**CITY OF MERCED**  
**Planning & Permitting Division**

**STAFF REPORT: #20-17**

**SUBJECT:** Vesting Tentative Subdivision Map #1313 and Conditional Use Permit #1244 (“Sage Creek”), initiated by Lamplight Capital & Asset Management, LLC, property owner. This application involves a request to subdivide one parcel (approximately 16 acres) into 103 single-family lots ranging in size from 4,600 square feet to 5,100 square feet, generally located on the north side of Monaco Drive, between El Redondo Drive and Horizons Avenue, within Planned Development (P-D) #50, with a General Plan designation of Village Residential (VR). \*PUBLIC HEARING\*

**DMC**  
**TM1**  
**SHEET**  
**1**  
**CITY OF MERCED**  
**CALIFORNIA**  
**OF 1**

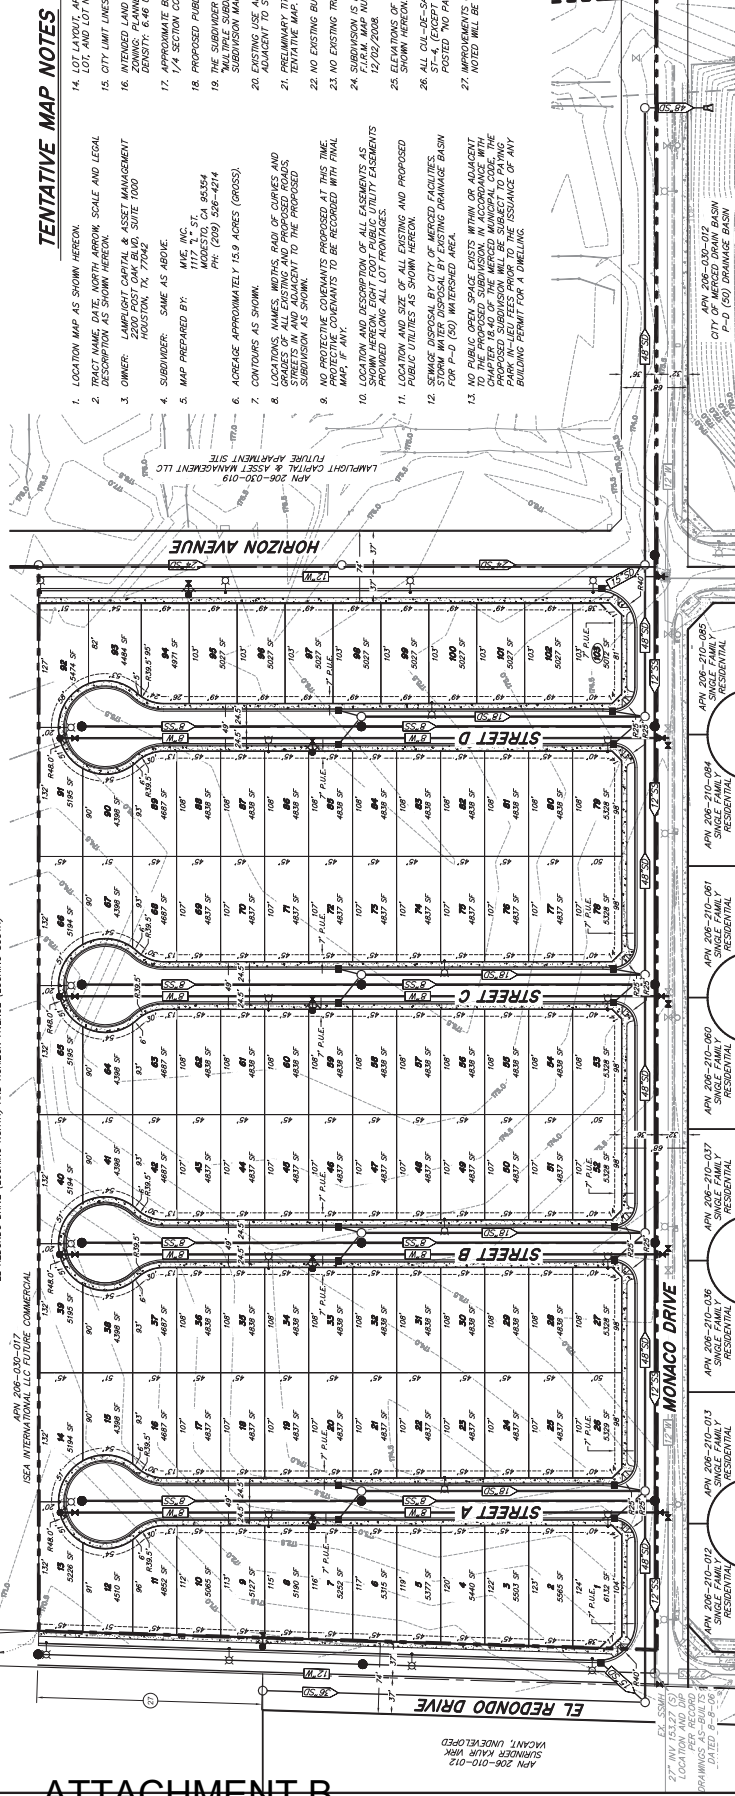
The right-of-way widths of the new cul-de-sacs would be 49 feet (even though Attachment B of Planning Commission Staff Report #20-17 shows 48 feet), including 5.5 feet on each side of the street to accommodate sidewalks. This meets the City's right-of-way requirement for local streets. However, the cul-de-sac bulb needs to have a minimum 48-foot-radius to accommodate Fire engine/refuse truck turning radius (Condition #22 of Planning Commission Staff Report #20-17).

- 22) The cul-de-sacs shall be designed with a minimum 48-foot radius to meet City Fire Department Standards.
